**TOWN OF MOUNTAIN VILLAGE  
REGULAR DESIGN REVIEW BOARD MEETING AGENDA  
THURSDAY NOVEMBER 2, 2023, 10:00 AM  
MOUNTAIN VILLAGE TOWN HALL  
455 MOUNTAIN VILLAGE BLVD, MOUNTAIN VILLAGE, COLORADO  
TO BE HELD HYBRID THROUGH ZOOM:  
https://us06web.zoom.us/j/88606387563  
Meeting ID: 886 0638 7563**

**TO:** Mountain Village Design Review Board  
**FROM:** Claire Perez, Planner II  
**FOR:** Design Review Board Public Hearing; November 2, 2023  
**DATE:** October 3, 2023  
**RE:** Staff Memo –Initial Architecture and Site Review (IASR) for Lot 161A-4 Unit 12

**WEST ELEVATION**  
 1/8" = 1'-0"

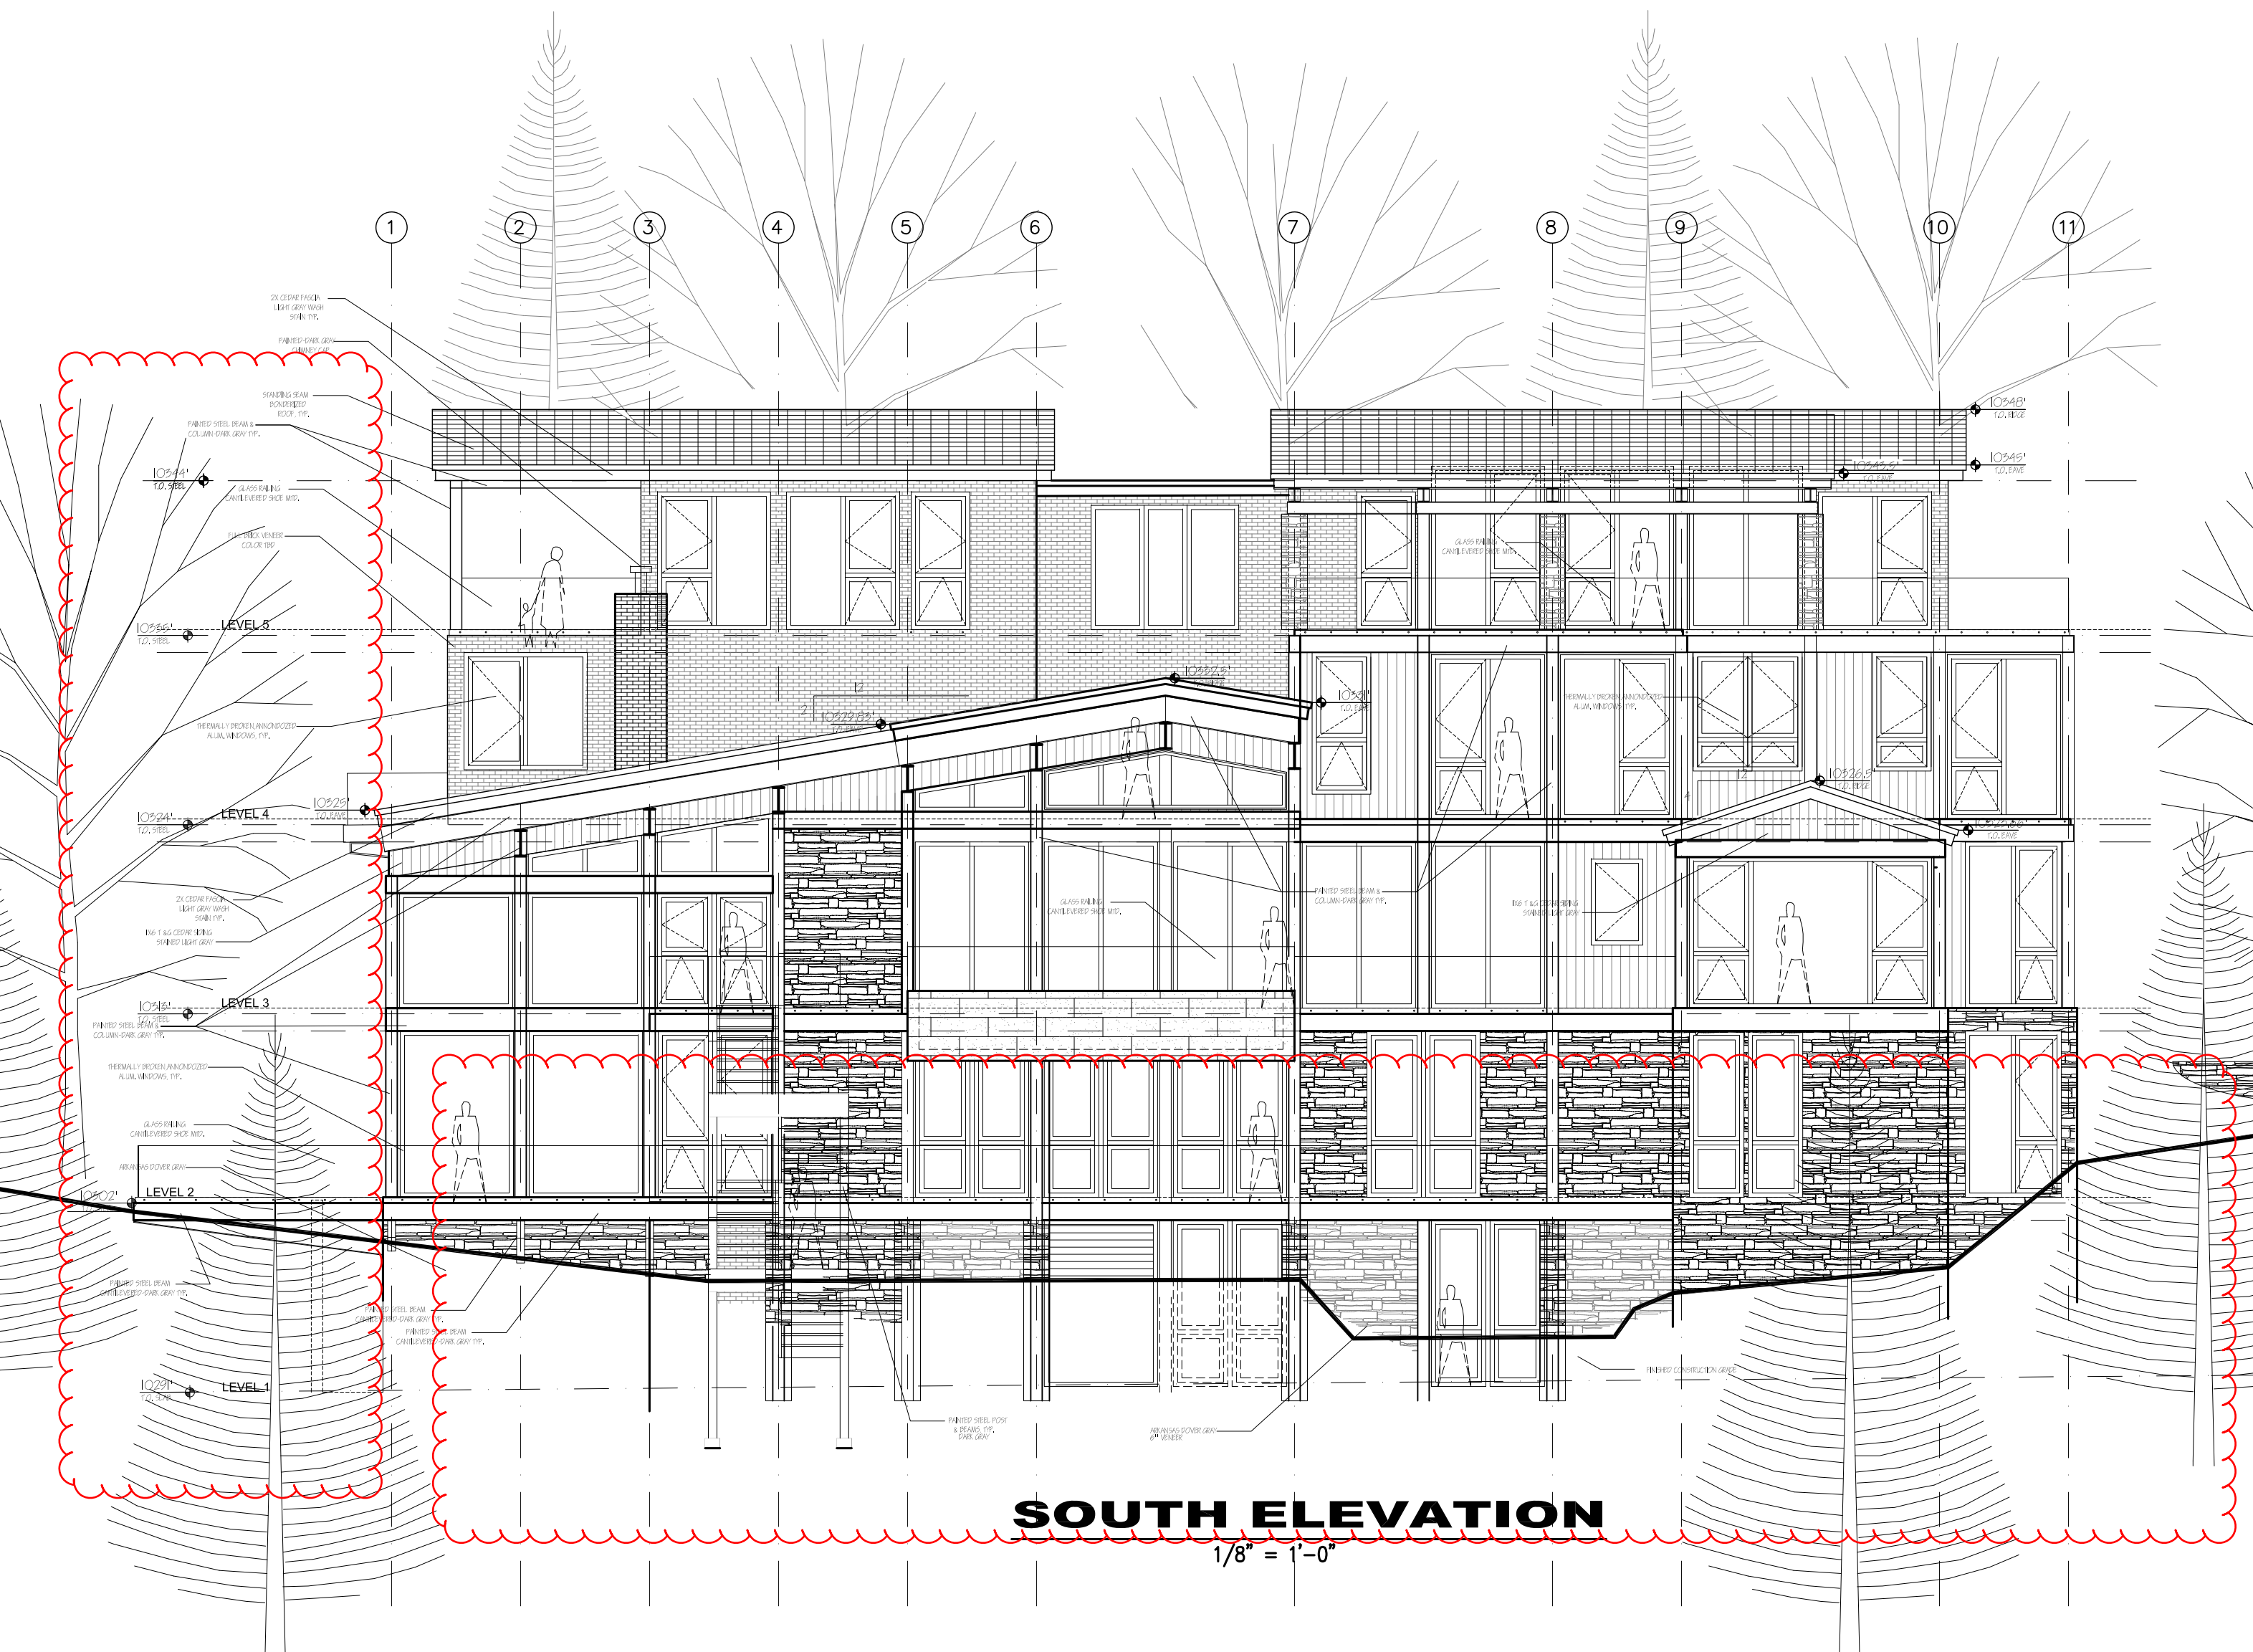
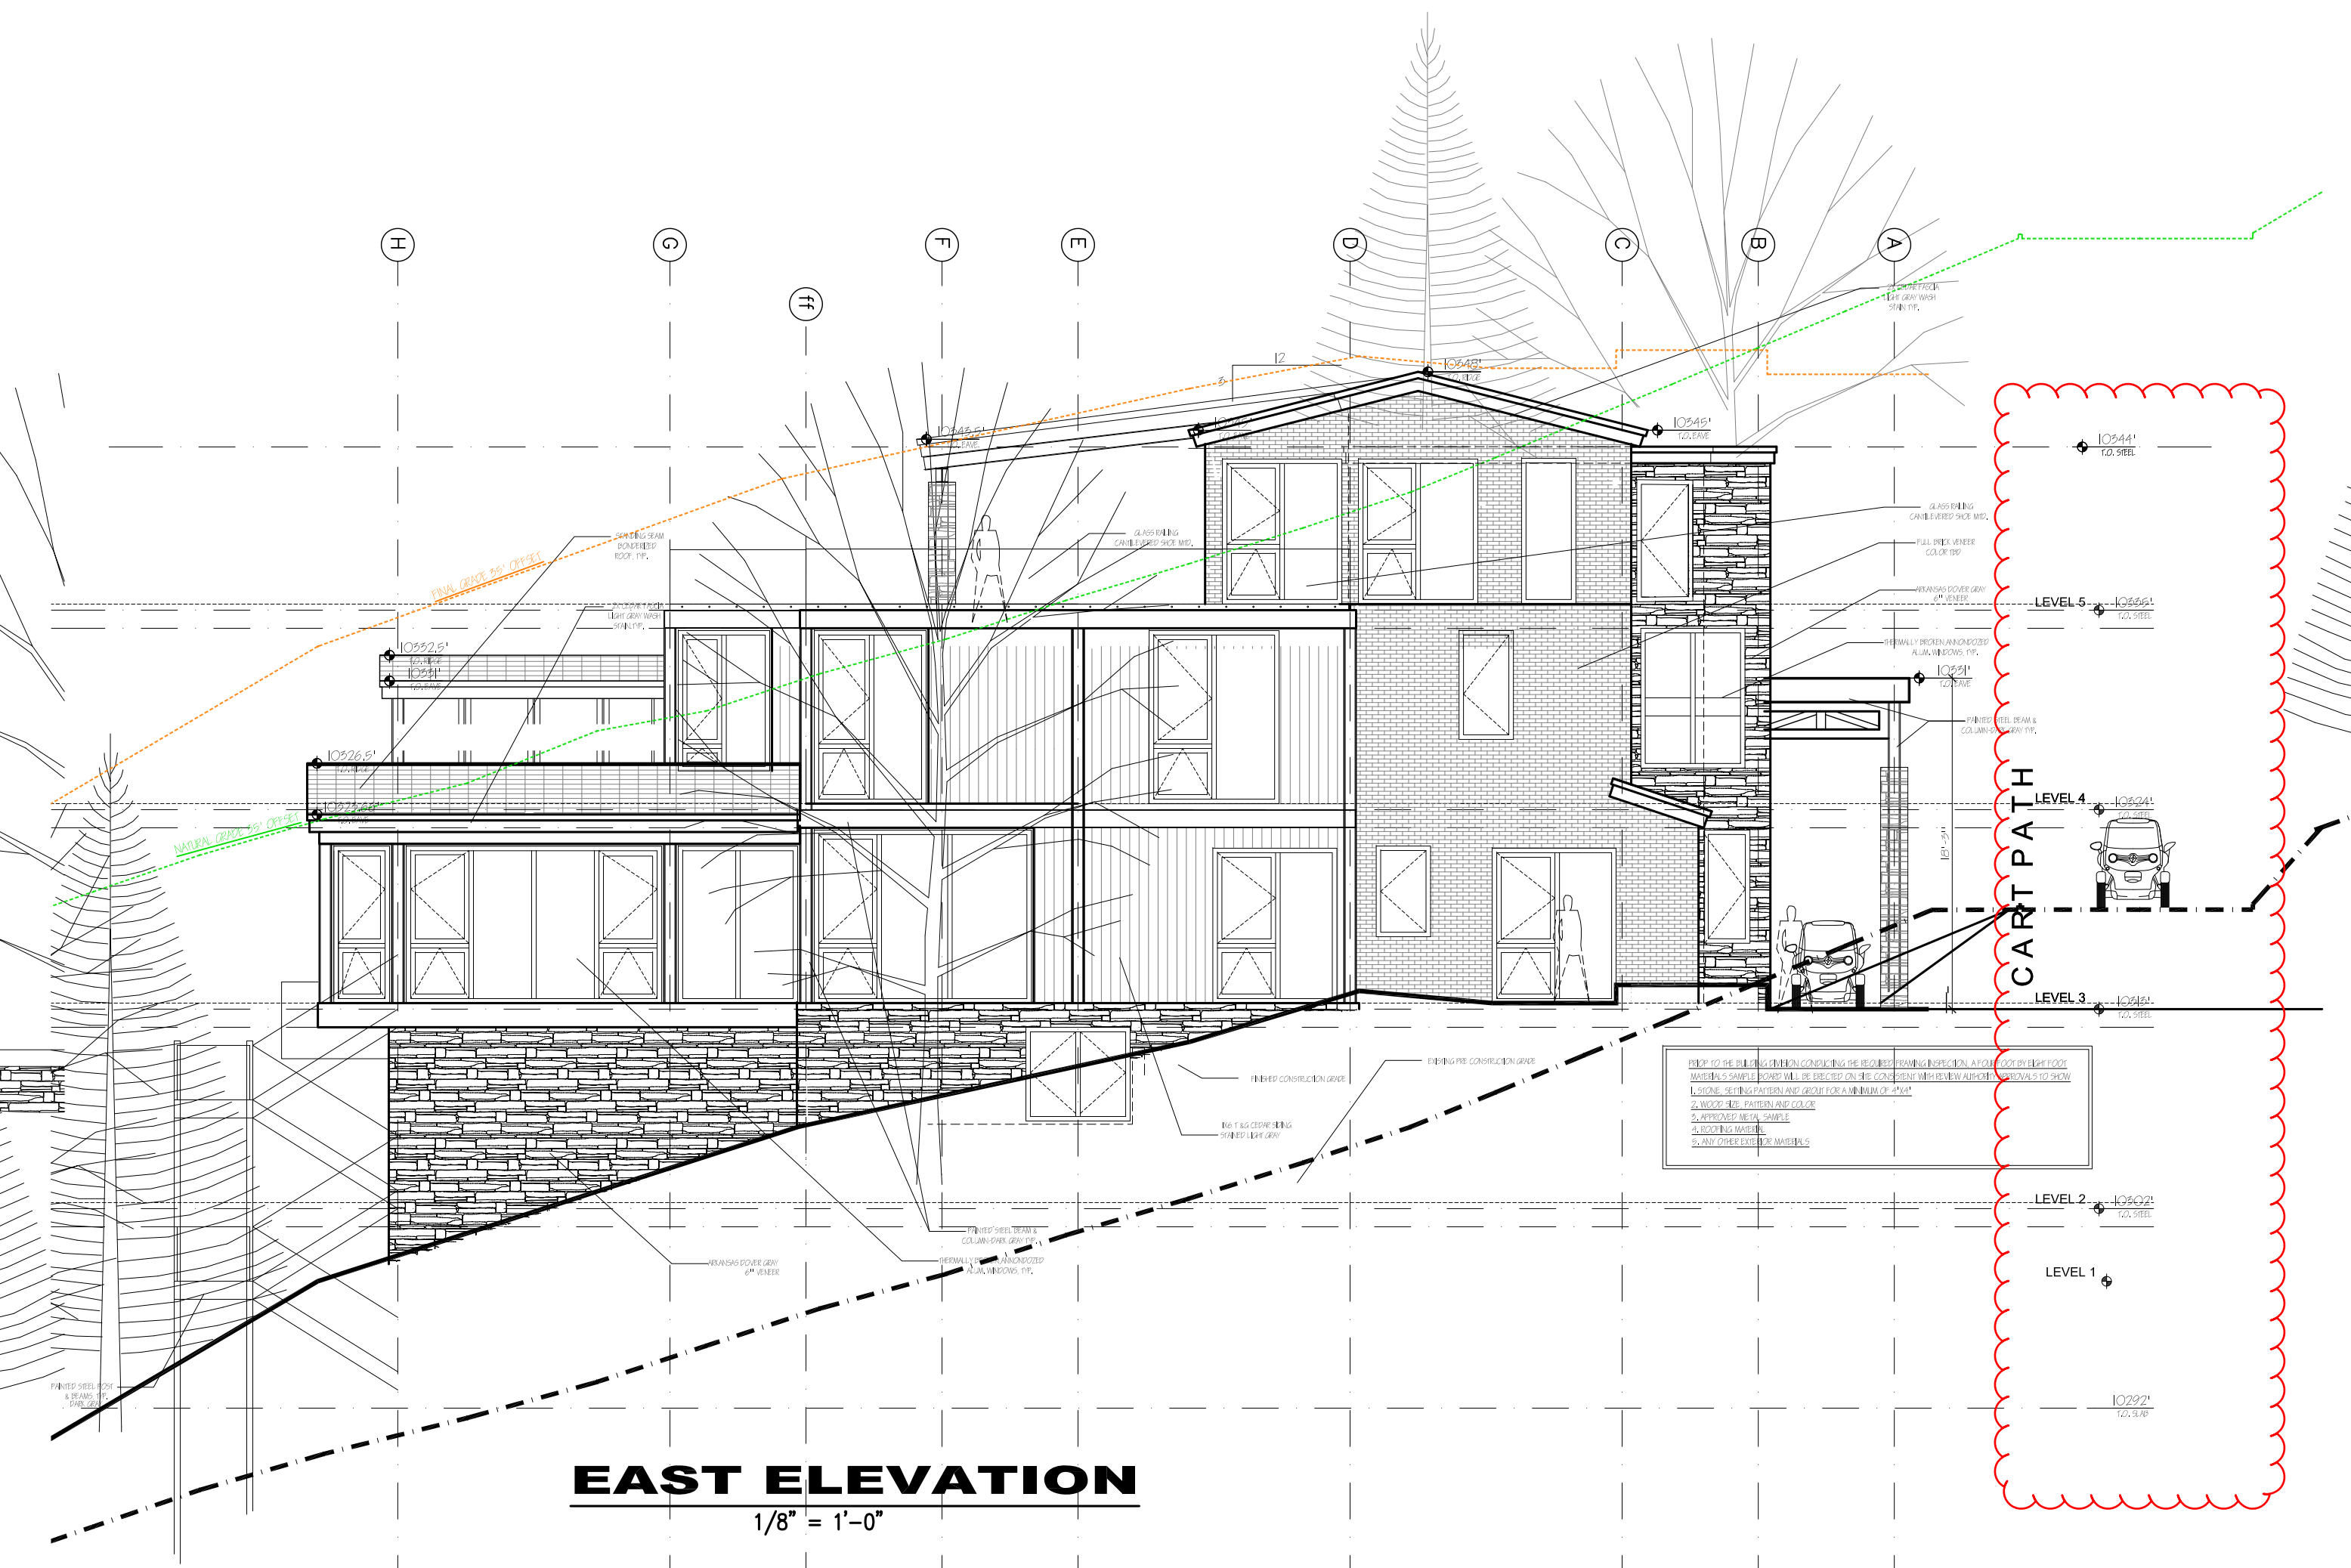
*Staff: The Maximum Building Height and Average Building Height analysis has been provided on page A1-3.1 of the submitted plan set and shows a Maximum Height of 35' and a Max Average Height of 30'-7 1/2". These metrics meet the height requirements granted by the variance for the lot.*

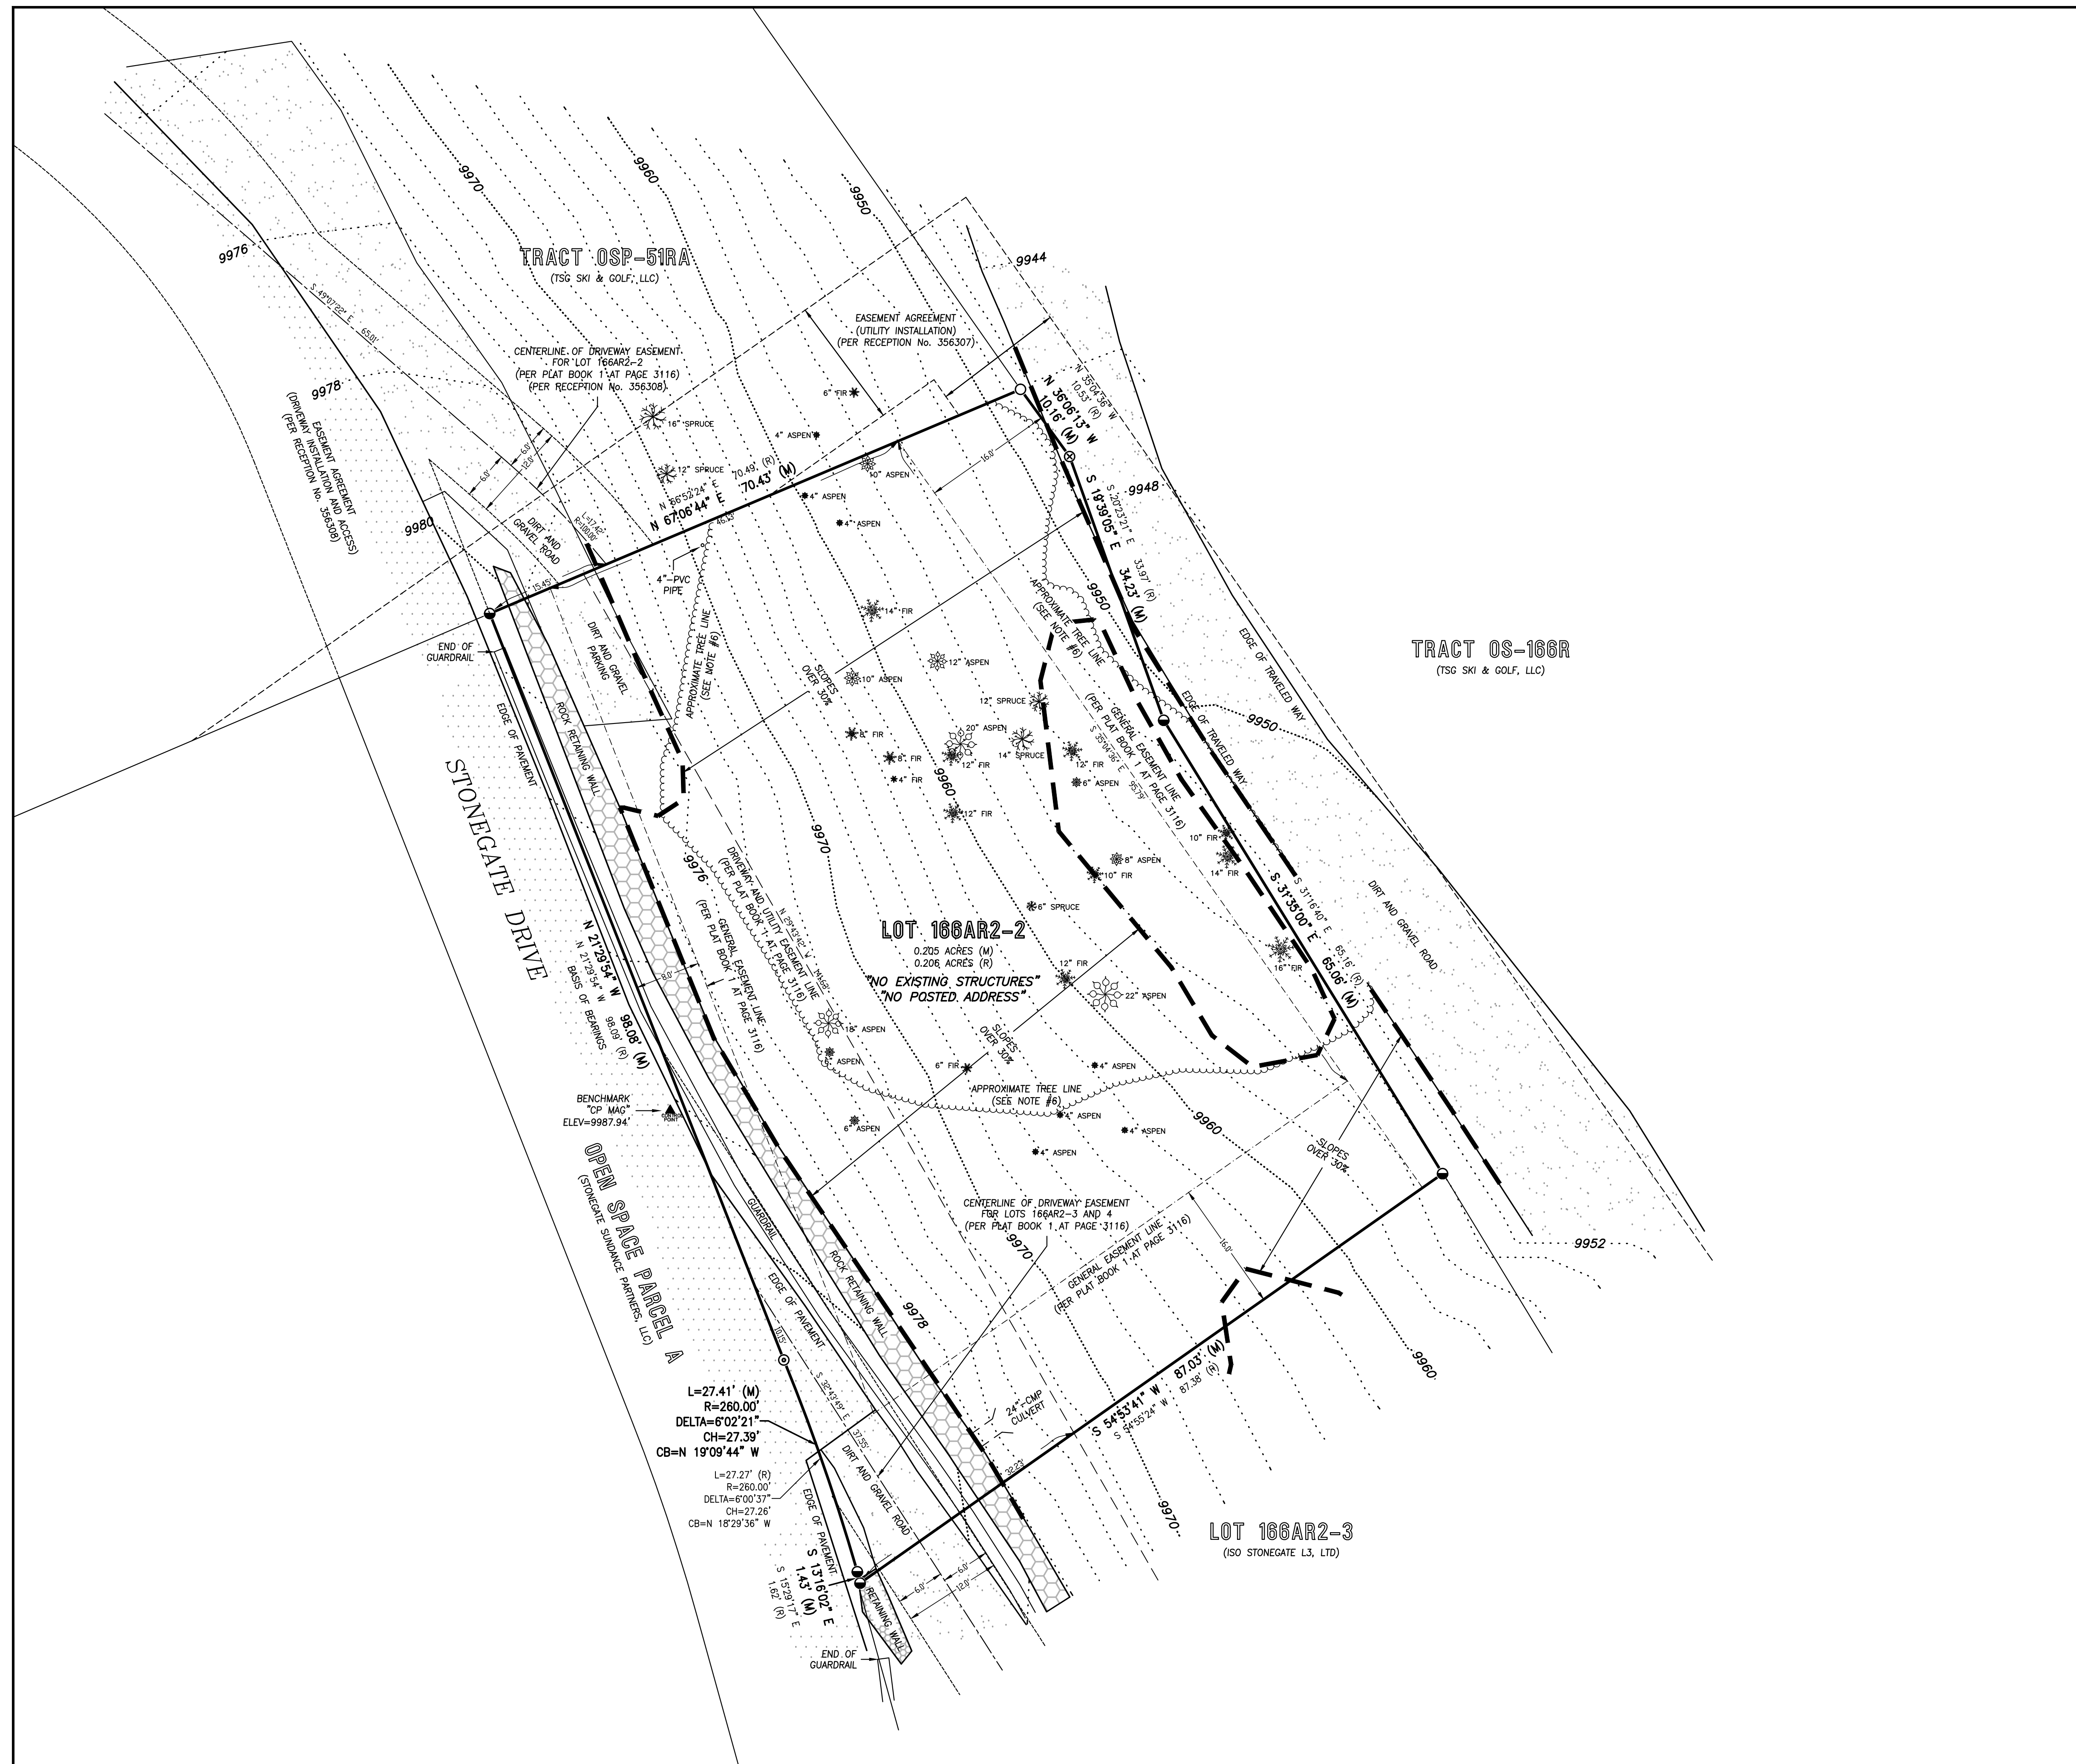
The existing steep slope of Lot 166AR-2 grading proposed is the same as previously approved in 2021 and remains what we believe is the best solution for a challenging site. It has an existing retaining wall that continues to show signs of failure as shown in the images below.

The previous approval demonstrated how the retaining wall would be rebuilt which is also delineated on the soil nail drawings and calculations. Construction of the single-family adjacency to the retaining wall reconstruction within a confined and steeply sloped site was a concern. Keeping the house separate from the retaining wall is still considered to be the best solution.
